PHOTOGRAPHS

PHOTOGRAPH #6

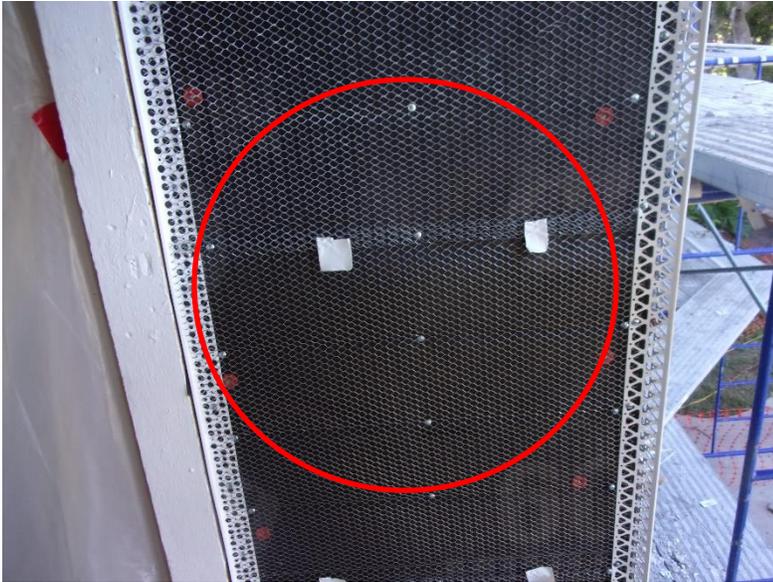
Missing sealant marked for correction at stucco stop accessory juncture.

Missing sealant at stucco stop accessory juncture sealed.

PHOTOGRAPH #7

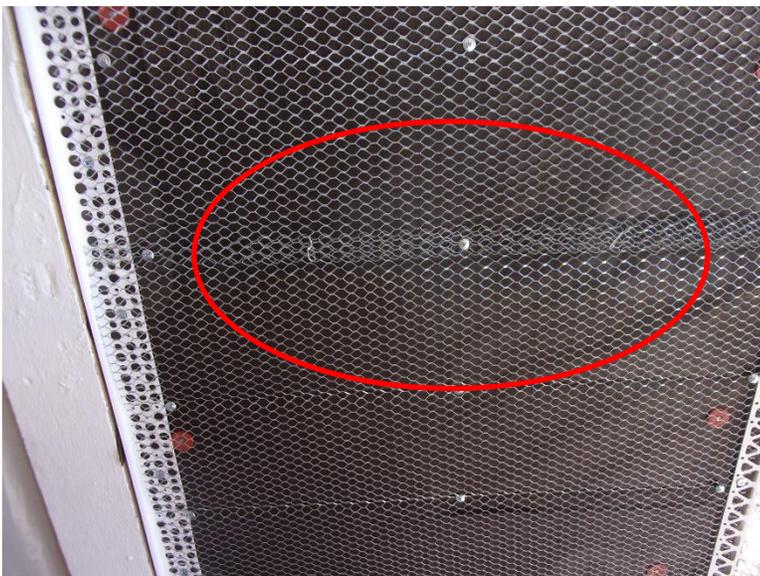
Missing tie wires at metal lath lapping
marked for correction.

Missing tie wires at metal lath lapping
corrected.
